**Environmental Impact Assessment (EIA) Ordinance, Cap. 499
Application for Variation of an Environmental Permit**

**Project Title: Hong Kong-Zhuhai-Macao Bridge – Hong Kong Boundary Crossing Facilities
(Application No. VEP-498/2016)**

Pursuant to Section 13(5) of the EIA Ordinance, we have amended the Environmental Permit (EP-353/2009/J). I attach the Environmental Permit as amended (No. EP-353/2009/K) for your use.

Figure 27
圖27

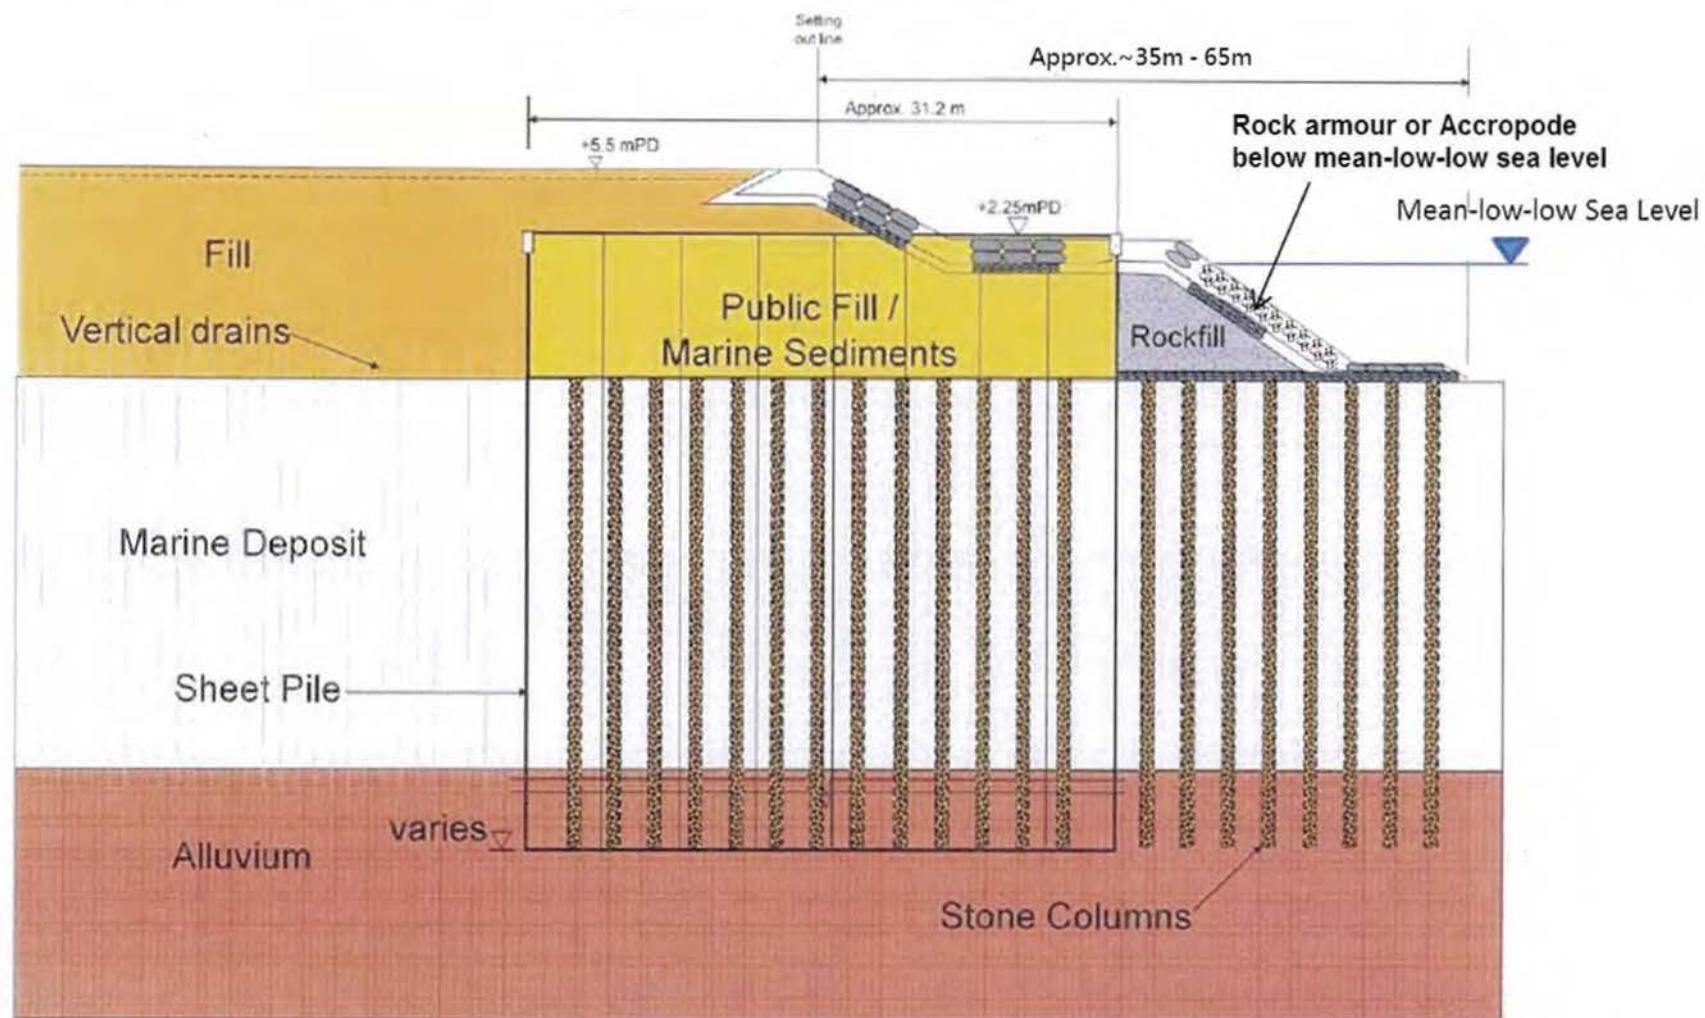
Application No. 申請書編號	Date of Application 申請日期	List of Amendments Incorporated into this Environmental Permit 已包含在本環境許可證內的修訂項目	Date of Amendment 修訂日期
		(2) Add Conditions 3.27 and 3.28 to Part C of the Environmental Permit (No. EP-353/2009/H) (二) 在環境許可證(編號 EP-353/2009/H) C 部加入第 3.27 至 3.28 項條件	
VEP-497/2016	18 February 2016 2016 年 2 月 18 日	(1) Vary Conditions 1.7, 3.24 to 3.26 to Part C of the Environmental Permit (No. EP-353/2009/I) (一) 更改環境許可證(編號 EP-353/2009/I) C 部的第 1.7、3.24 至 3.26 項條件 (2) Add Condition 3.26A to Part C of the Environmental Permit (No. EP-353/2009/I) (二) 在環境許可證(編號 EP-353/2009/I) C 部加入第 3.26A 項條件	25 February 2016 2016 年 2 月 25 日
VEP-498/2016	24 March 2016 2016 年 3 月 24 日	(1) Vary Condition 1.7 to Part C of the Environmental Permit (No. EP-353/2009/J) (一) 更改環境許可證(編號 EP-353/2009/J) C 部的第 1.7 項條件 (2) Vary Figure 27 to Environmental Permit (No. EP-353/2009/J) (二) 修改環境許可證 (編號 EP-353/2009/J) 圖 27	11 April 2016 2016 年 4 月 11 日
